FIG. 1

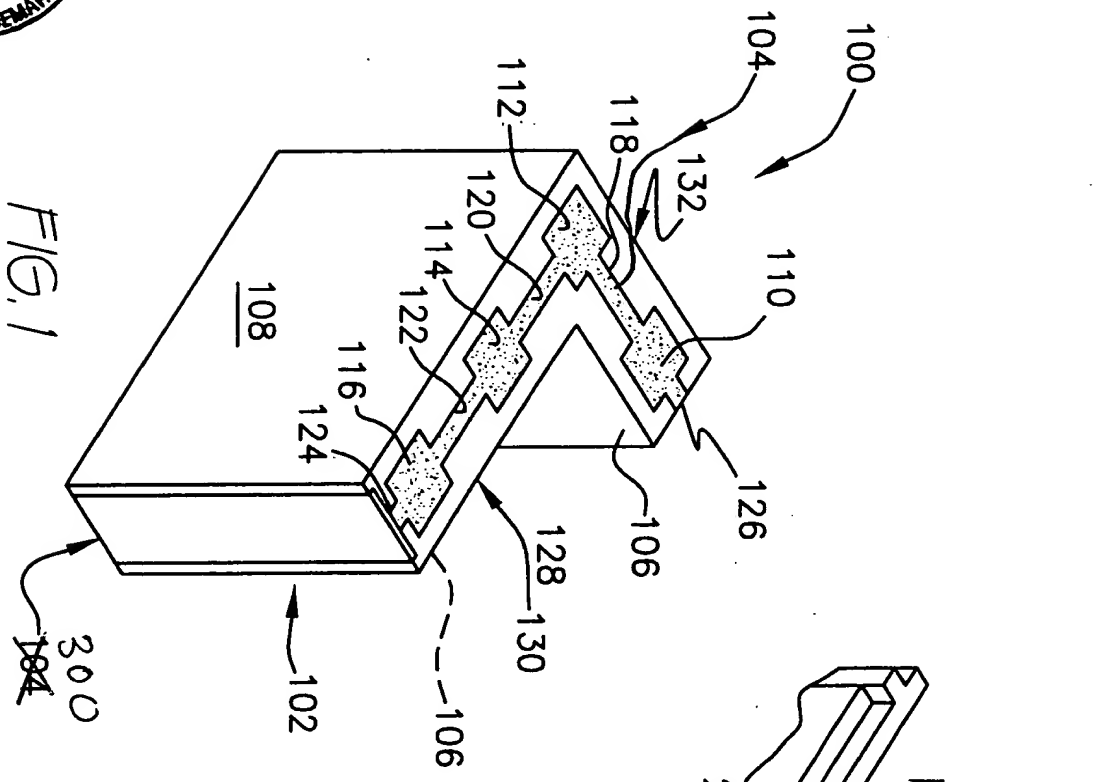
serial number was included on line 7. Additionally, the term "oblique" was deleted in that it was an inappropriately chosen term describing the angle 128 of corner form 100. As clearly seen in Fig 1, angle 128 is not inclusive of an oblique angle, wherein oblique angles are defined as any angles except for right angles. In as much as it is overwhelmingly common building practice to have corners of right angles, it is clear that this was an erroneously applied term. The use of this term which was also deleted in claim 11.

FIG. 2

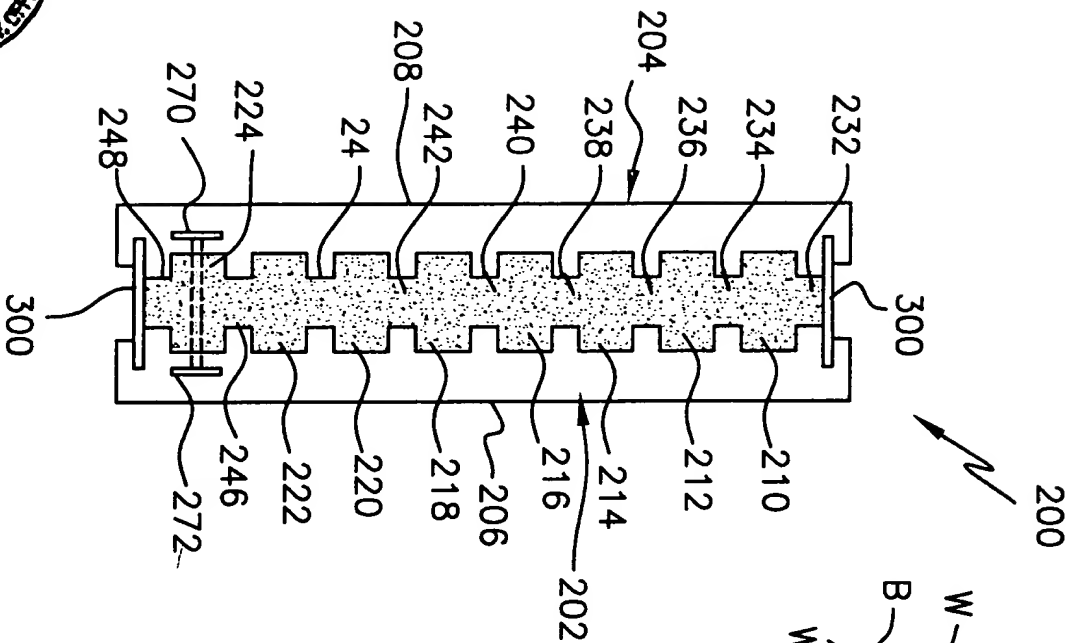
In Figure 2, the lead lines indicating the wedges formed, 232, 234, 236, 238, 240 and 242 were extended to properly show the wedges as described in the specification, see page 14 lines 13-18. No new matter was added.

On page 14, the specification was amended to include reference numerals 218, 220, 223, and 224 on line 8 and on line 9, the numeral "216" was replaced with -224- to properly describe the range of posts as shown in Figure 2.

Also on page 14, at line 18 a sentence was included to properly describe the reference numeral and lead line of element 24 shown in Figure 2. Projections 24 aids in the forming of the voids described throughout the specification and claims which form the intersecting posts and beams and wedges as disclosed. No new matter was added.

FIG. 4

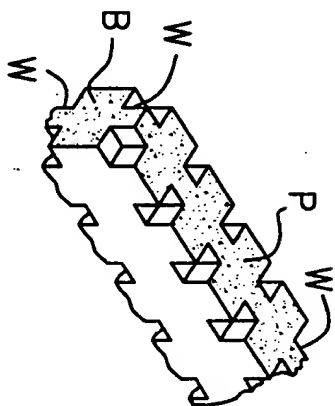
As to claim 3, the language directed toward the "parallel and perpendicular" posts and beams relative to said first and second insulating panels was rendered indefinite. Claim 3 has been canceled, however this limitation was used in the presently amended claims 2 and 13. Nonetheless, the language has been changed to clearly describe the resulting concrete form as illustrated in Figure 4.

FIG. 3

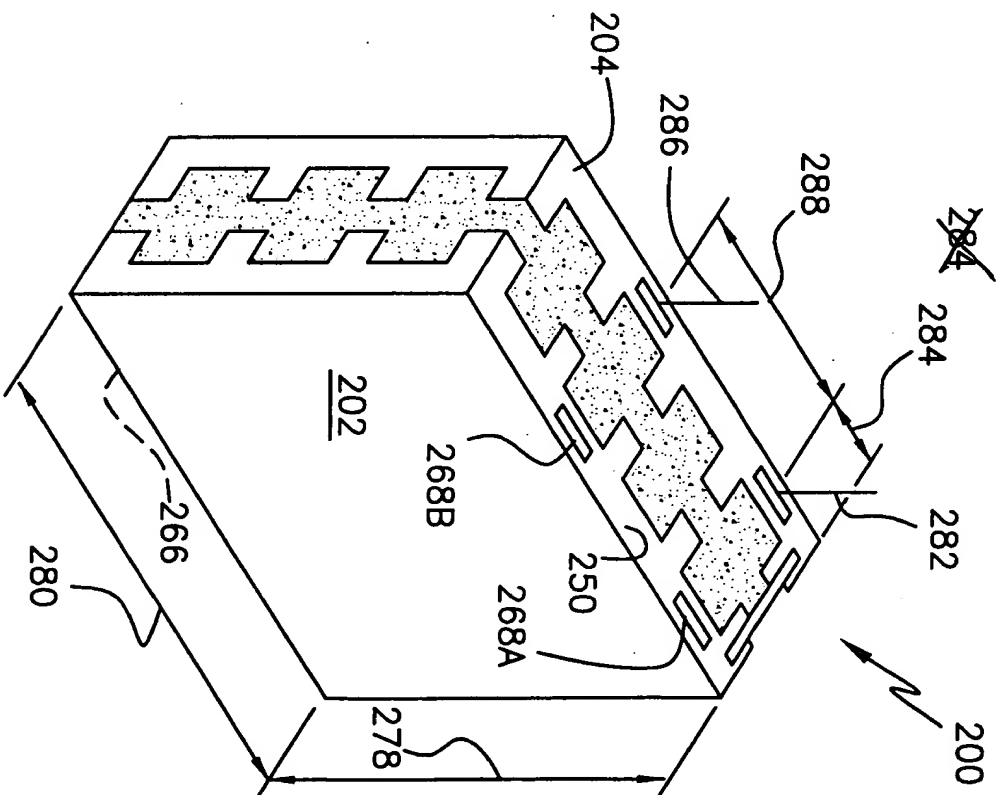
In Figure 3, reference numeral '284' was placed in the figure twice. One occurrence of the numeral 284 was removed. No new matter was added.
